LIAISON NOTE

VTS Digital Services Architecture Development

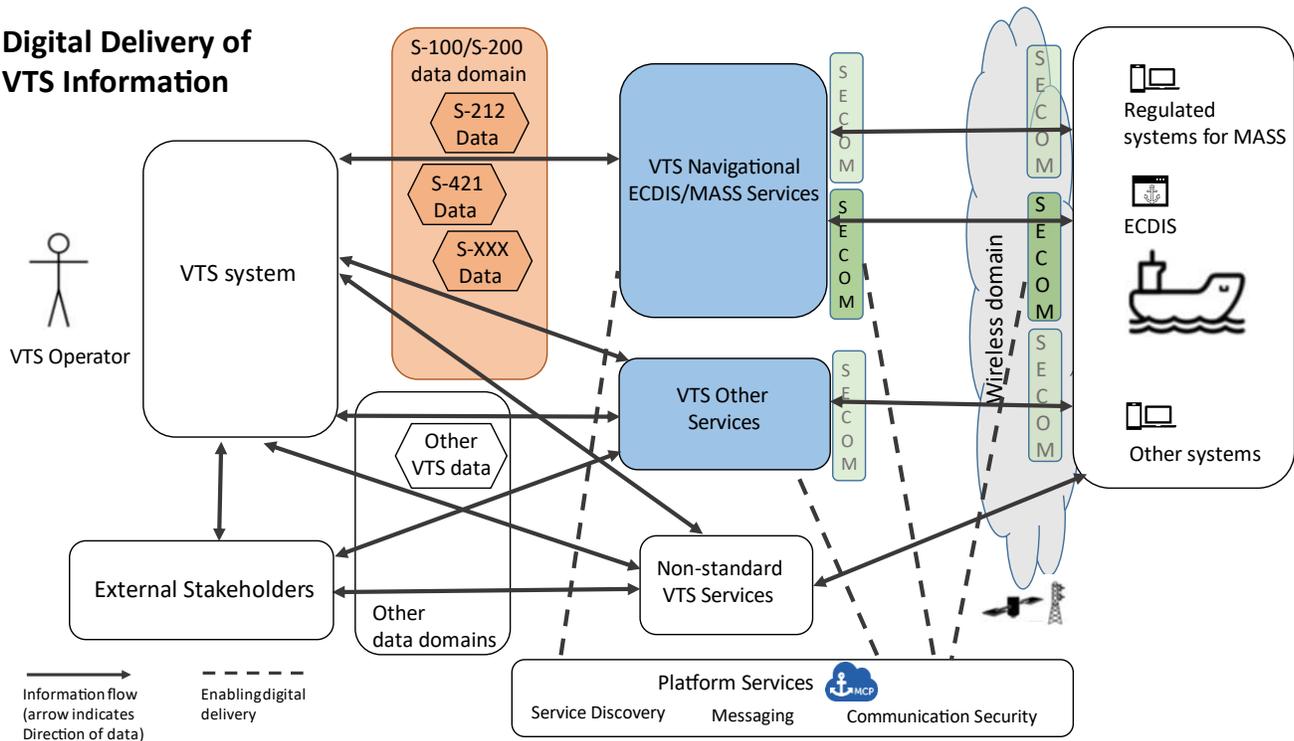
- Specify that referencing to SECOM includes both the security aspects and the SECOM API
- Notice that the wireless domain might be between equipment on the ship and SECOM service for the ship

- Explain the coloured arrows - or change arrows to be in the same colour. Preferably use the same colour in order to reduce the complexity of the drawing.

- Connect or join the two blue boxes named 'VTS navigational services for MASS' and 'VTS navigational services for ECDIS/MASS', since the navigational MASS services are merely an extension of the set of services to ECDIS.

- Consider clarifying the role and naming of the Platform services as enablers for the Digital delivery of VTS Information
- Consider splitting the (rather complicated) drawing into two:

- A technical architecture – Focusing on the technical components (Services for ECDIS/MASS, other ship systems, non-standard services...)
 - Specification oriented drawing - Derived from technical architecture and highlights the role of different types of specifications related to various architectural elements (Product specifications, technical services, SECOM, MCP specifications...)

- Consider leaving digital delivery for External stakeholders out of the technical architecture drawing to make it less complex “Digital delivery of VTS Information for Ships” – or create separate drawing highlighting the digital delivery with External stakeholders

Below is a proposed updated drawing - which would be the technical architecture view in the document:
